Gregory Hills Corporate Park  
Camden Medical Campus

Issued for Section 4.55 Modification

MMD-368851-C-DR-CA-0001 P5  
Date: 16.01.2020

| Title                        |
|------------------------------|
| Key Design Changes           |

Title  
Gregory Hills Corporate Park  
Camden Medical Campus  
Civil Works  
General Arrangement

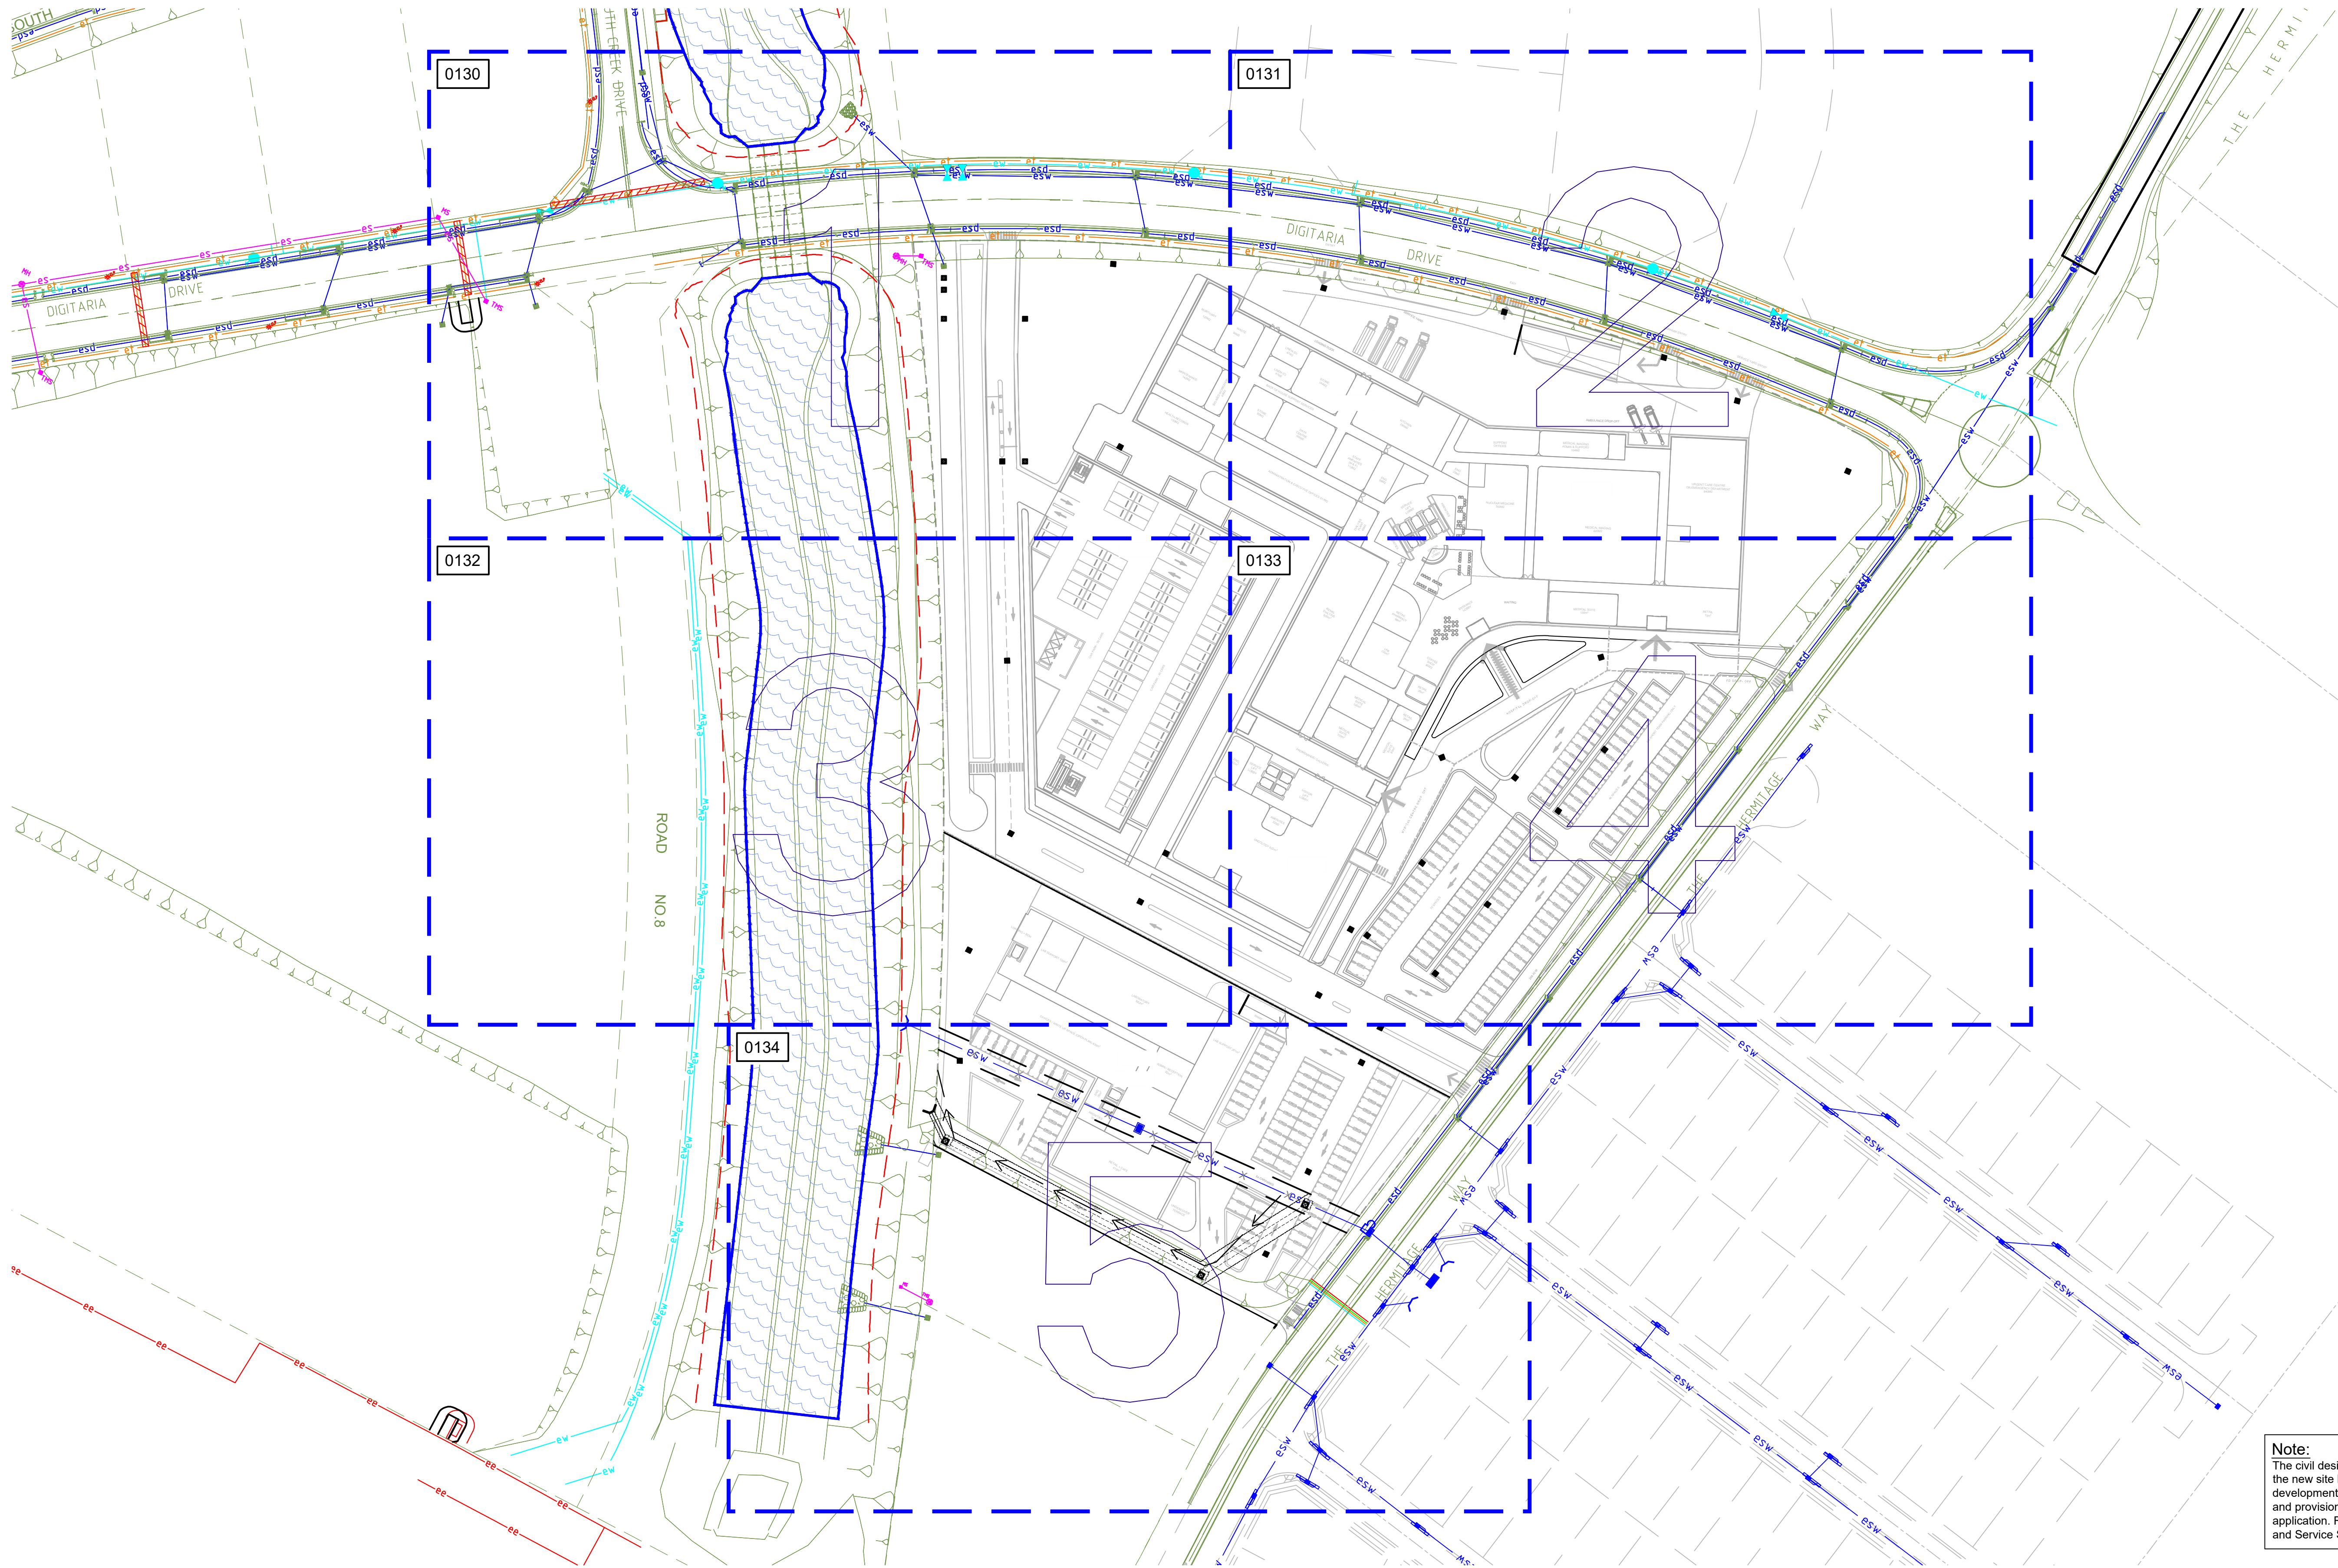
| Number | Key Design Elements Impacted                          | Comments                                                                                                                                                                                                                                                                       |
|--------|-------------------------------------------------------|--------------------------------------------------------------------------------------------------------------------------------------------------------------------------------------------------------------------------------------------------------------------------------|
| 1      | External car park drainage and levels amended         | Car parking layout and location updated to suit new building footprint, changes to levels and drainage to accommodate                                                                                                                                                          |
| 2      | Line B drainage system extended                       | Changes to accommodate revised external layout                                                                                                                                                                                                                                 |
| 3      | Line N drainage system extended                       | Required to drain new low point                                                                                                                                                                                                                                                |
| 4      | Line E drainage system extended                       | Changes to accommodate revised external layout of car park                                                                                                                                                                                                                     |
| 5      | Line C drainage system extended                       | Changes to accommodate revised external layout of car park                                                                                                                                                                                                                     |
| 6      | Line D drainage system extended                       | Changes to accommodate revised external layout of car park                                                                                                                                                                                                                     |
| 7      | Line F drainage system extended                       | Changes to accommodate revised external layout of car park                                                                                                                                                                                                                     |
| 8      | Driveway locations updated                            | Driveway crossings on the eastern side of the site have been updated to correspond with new architectural scheme                                                                                                                                                               |
| 9      | Retaining wall added to southern boundary of the site | Due to the basement carpark extents under the research building and head clearance requirements, the design levels along the southern side of the research building have been lifted and a retaining wall is required to make up the level difference against the adjacent lot |

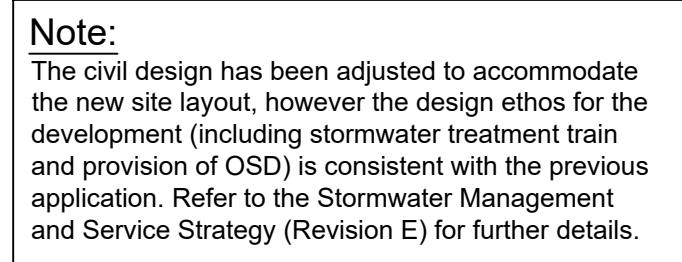
| Number | Key Design Elements Impacted                          | Comments                                                                                                                                                                                                                                                                       |
|--------|-------------------------------------------------------|--------------------------------------------------------------------------------------------------------------------------------------------------------------------------------------------------------------------------------------------------------------------------------|
| 1      | External car park drainage and levels amended         | Car parking layout and location updated to suit new building footprint, changes to levels and drainage to accommodate                                                                                                                                                          |
| 2      | Line B drainage system extended                       | Changes to accommodate revised external layout                                                                                                                                                                                                                                 |
| 3      | Line N drainage system extended                       | Required to drain new low point                                                                                                                                                                                                                                                |
| 4      | Line E drainage system extended                       | Changes to accommodate revised external layout of car park                                                                                                                                                                                                                     |
| 5      | Line C drainage system extended                       | Changes to accommodate revised external layout of car park                                                                                                                                                                                                                     |
| 6      | Line D drainage system extended                       | Changes to accommodate revised external layout of car park                                                                                                                                                                                                                     |
| 7      | Line F drainage system extended                       | Changes to accommodate revised external layout of car park                                                                                                                                                                                                                     |
| 8      | Driveway locations updated                            | Driveway crossings on the eastern side of the site have been updated to correspond with new architectural scheme                                                                                                                                                               |
| 9      | Retaining wall added to southern boundary of the site | Due to the basement carpark extents under the research building and head clearance requirements, the design levels along the southern side of the research building have been lifted and a retaining wall is required to make up the level difference against the adjacent lot |
